Nature of Work: REPLACE WASHED OUT SOIL UNDERSLAB W/ 1 1/2 TO 2 SACK SAND, SLOTTED & REPOUR SLAB

Report
Pioneer House
415 P Street
Sacramento, California

Mr. Daniel C. Tocci
Retirement Housing Foundation
911 N. Studebaker Road
Long Beach, CA 90815Subject: Pioneer House
Sacramento, California**OBSERVATION REPORT AND FLOOR LEVEL SURVEY RESULTS**References: ENGEO Incorporated; Geotechnical Recommendation for Pioneer House in
Sacramento, California; Project Number 7293.5.001.01; dated April 14, 2006.

GEOTECHNICAL RECOMMENDATION

FIGURE NO.
1

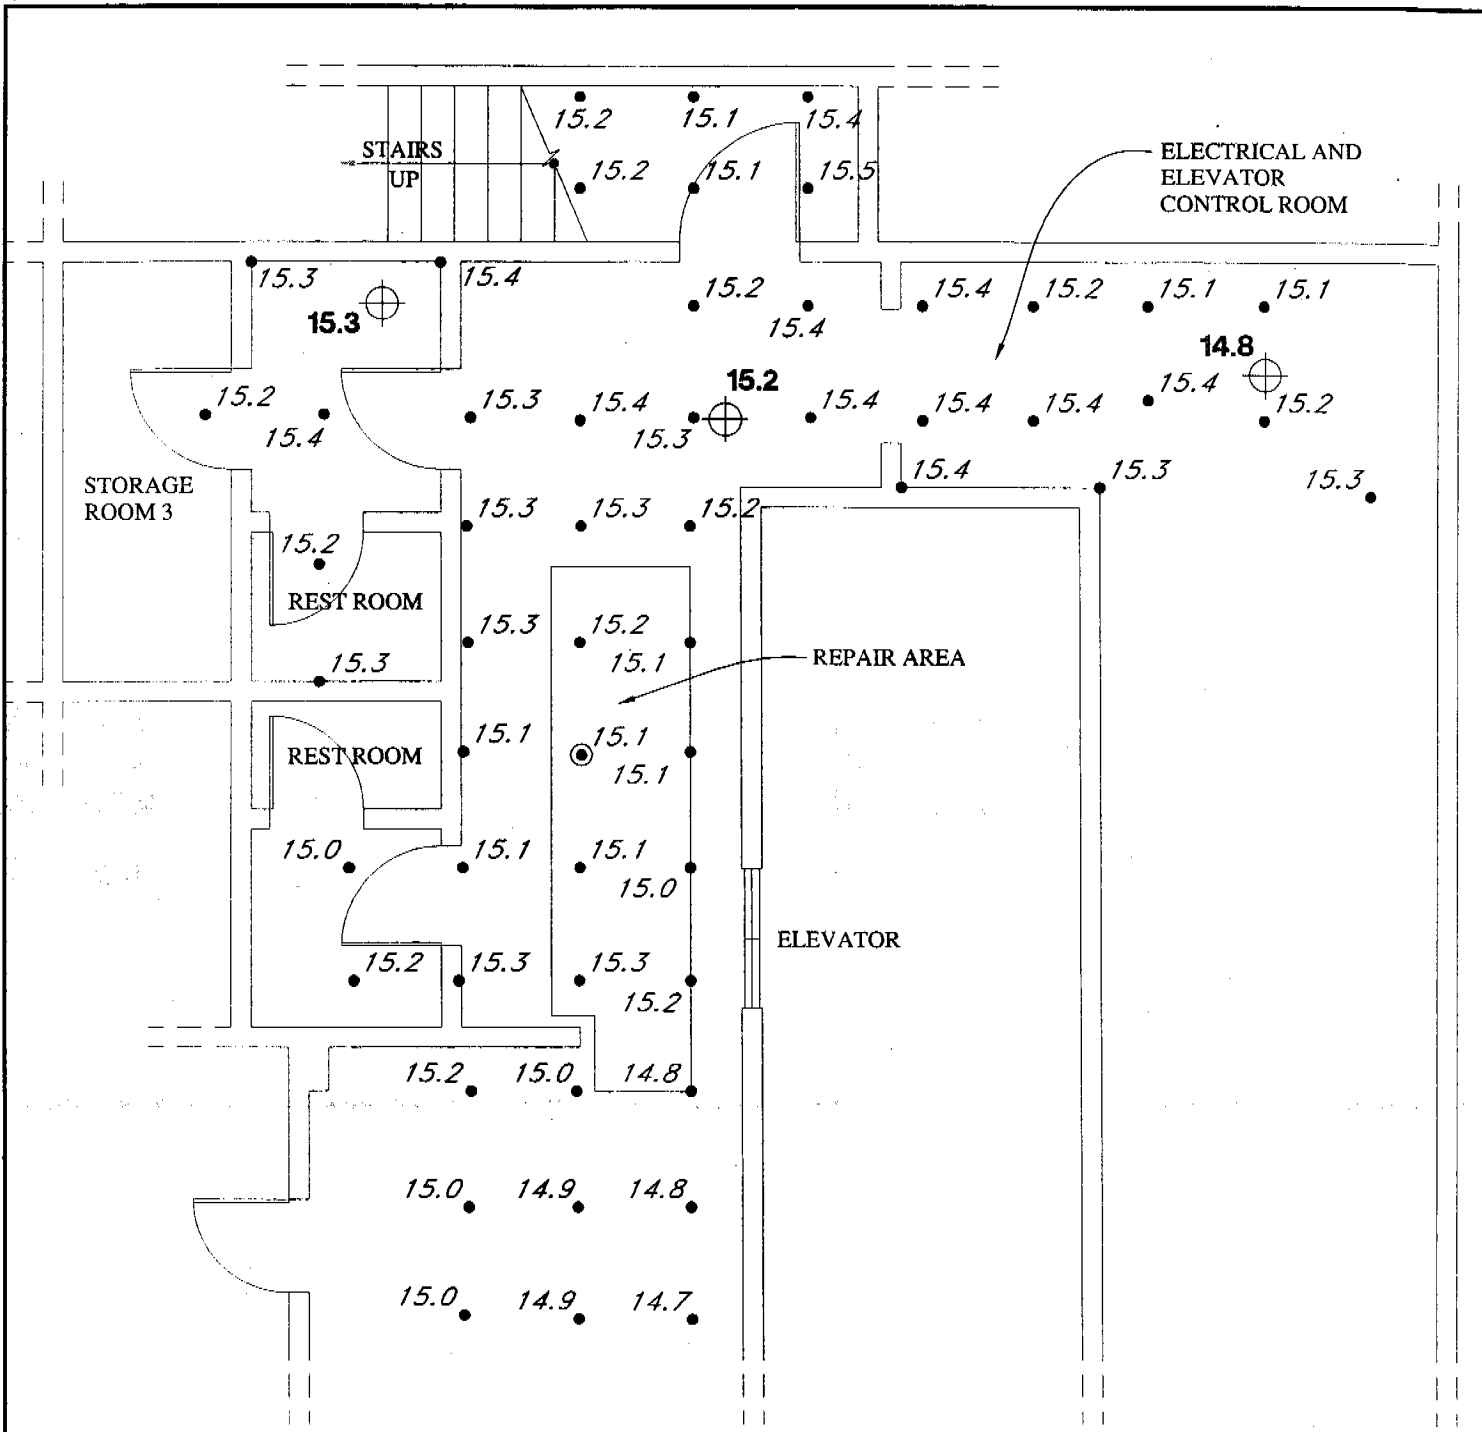
On September 7, 2006, we returned to the basement of the subject site to perform floor level survey. The repairs to the concrete floor slab had been performed prior to our arrival. The results of the floor level survey are presented on the attached Figure 1. The results show the relative floor level elevations in the vicinity of the repair area and the grout pump core holes. These results can be used as a baseline to evaluate any concerns as to future settlement in this area of the floor slab associated with the void repair.
